service bulletin

No. 91-9

A. OIL LEAKING FROM WATER PICKUP HOLES IN GEAR HOUSING ON ALPHA ONE GENERATION II DRIVE

MCM 3.0L/3.0LX/4.3L/4.3LX/5.0L/5.0LX/5.7L Alpha/350 Magnum

A. Old Style **B. New Style**

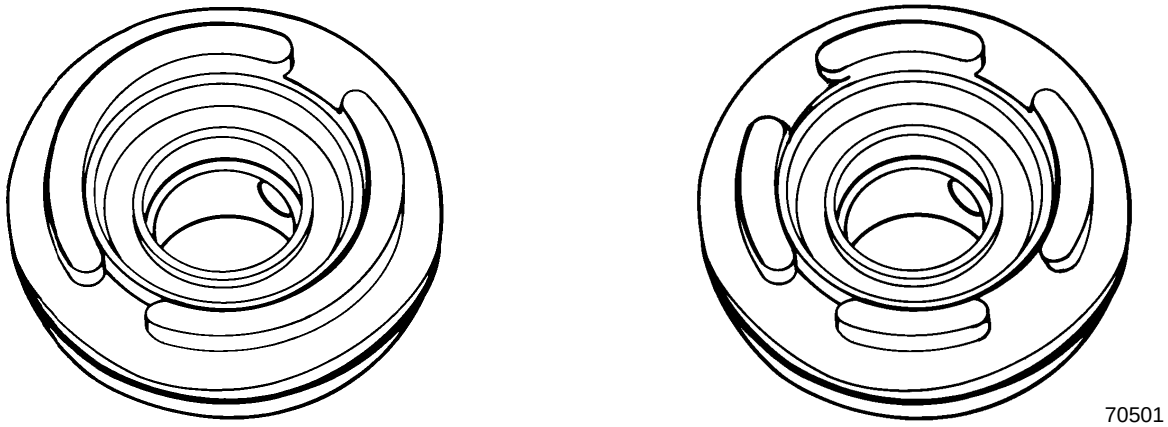
The oil seal carrier is being changed from the brown color (aluminum) material back to a black glass filled nylon material. This new seal carrier will supercede the aluminum version. The new seal carrier can be identified by looking at the base where the old plastic carrier had only two support feet the new one will have four support feet.

1 seal carrier ▲821759A2

70489

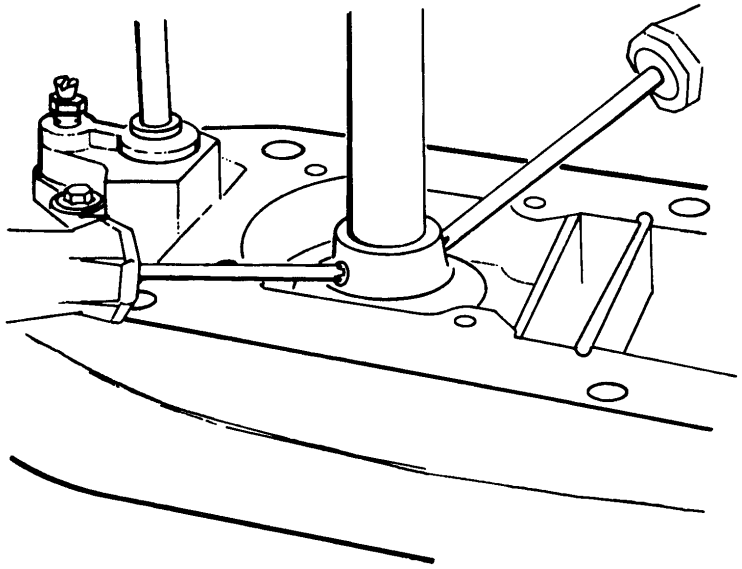
If oil is detected leaking from the water pickup holes in the gear housing, the oil seal carrier under the water pump face plate may be cracked. This would cause oil to leak from the water pickup holes in the gear housing and could lead to gear failure.

Remove cracked carrier from gear housing using a couple of screw drivers to lift it up and out of the housing bore.
